PASSE 1.2 VI  
Q-6 12/13/84

EVALUATION OF THE PASCO SANITARY  
LANDFILL WASTE DISPOSAL PRACTICES

J-U-B ENGINEERS, Inc.

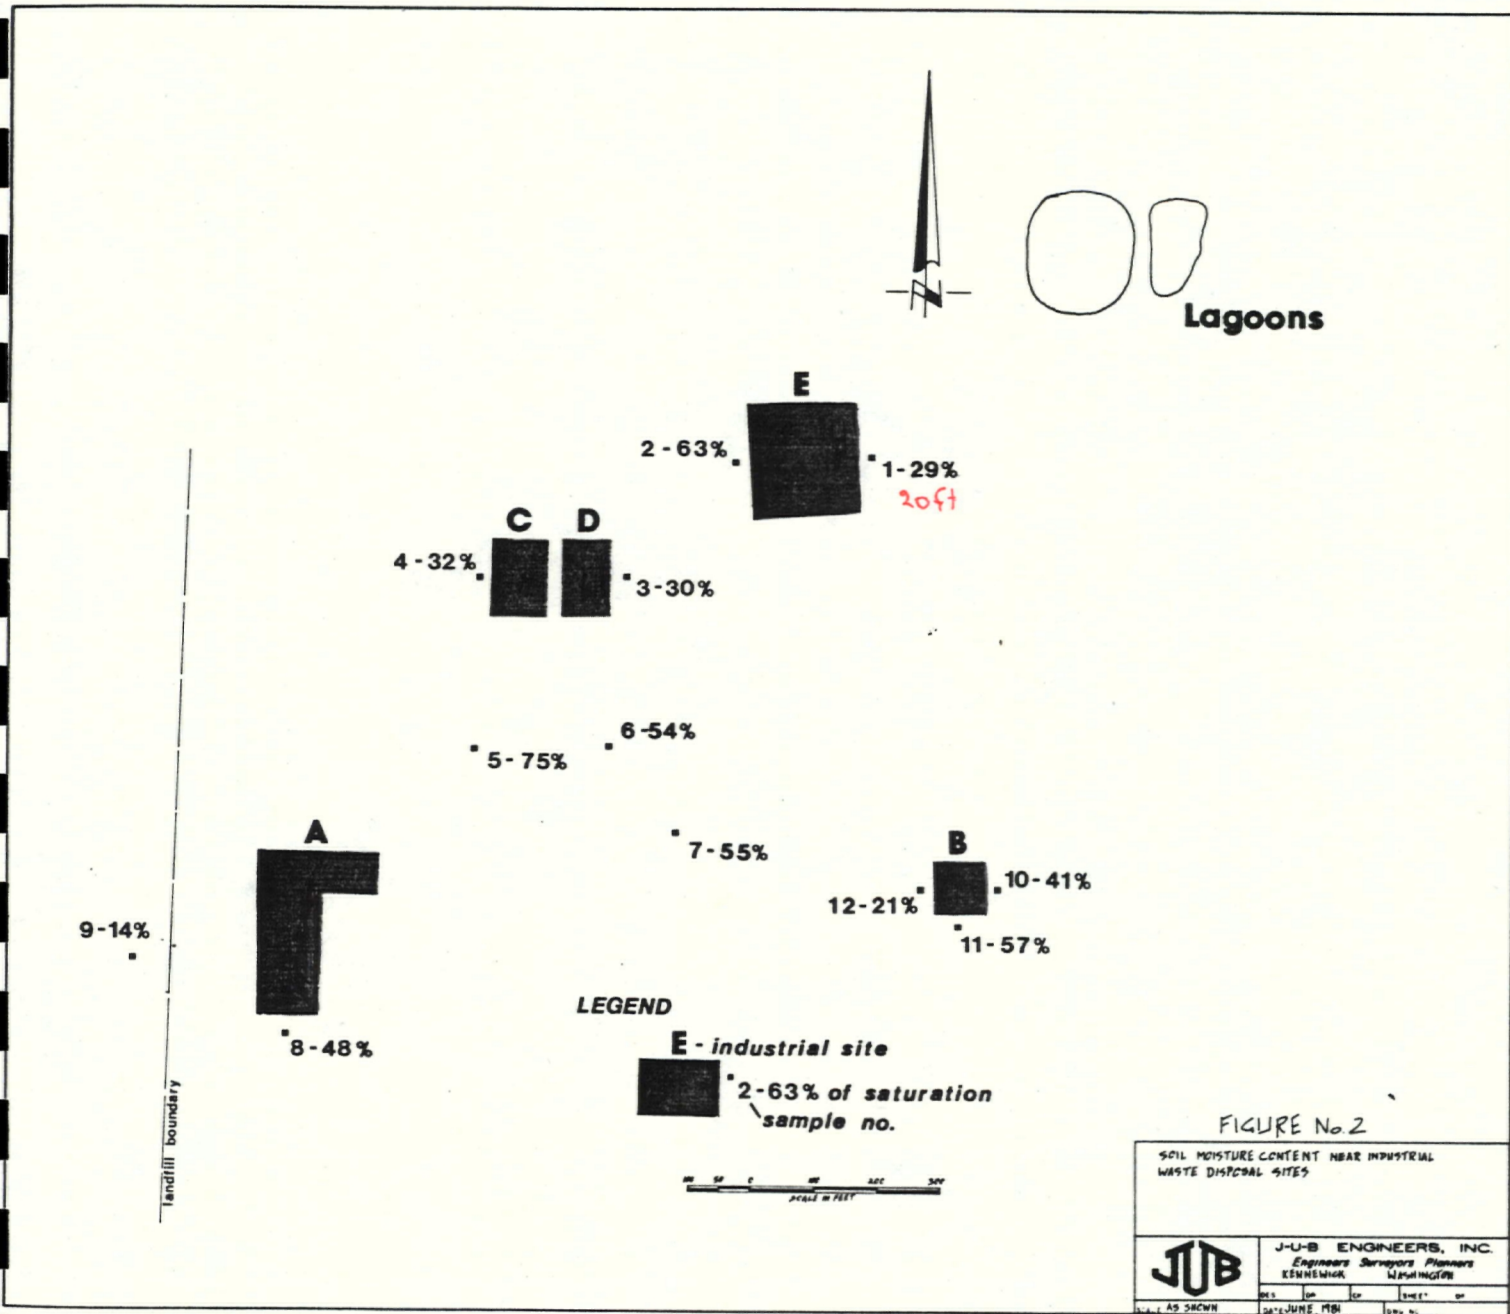
2. "There is a potential for saturation of adjacent soil containing previously deposited industrial materials."

Saturation could occur from seepage percolating laterally from the lagoons to the industrial sites. The degree of saturation was determined in the vicinity of all of the industrial waste sites and a control site away from the waste disposal facility. The exact depth of the buried industrial waste was estimated by the landfill operator and samples were taken at 1, 3, 5, 10, 15 and 20 foot intervals dependent upon the depth of the buried industrial waste and observations in the field at the time of sampling. Table 1 shows the degree of saturation at each of the sites analyzed.

Figure 2 shows the relative locations of the lagoons, industrial waste disposal sites, and the sampling locations. The degree of saturation is indicated for the deepest depth at each location. The figure illustrates that the sites are not being saturated from lateral percolation of lagoon wastewaters.
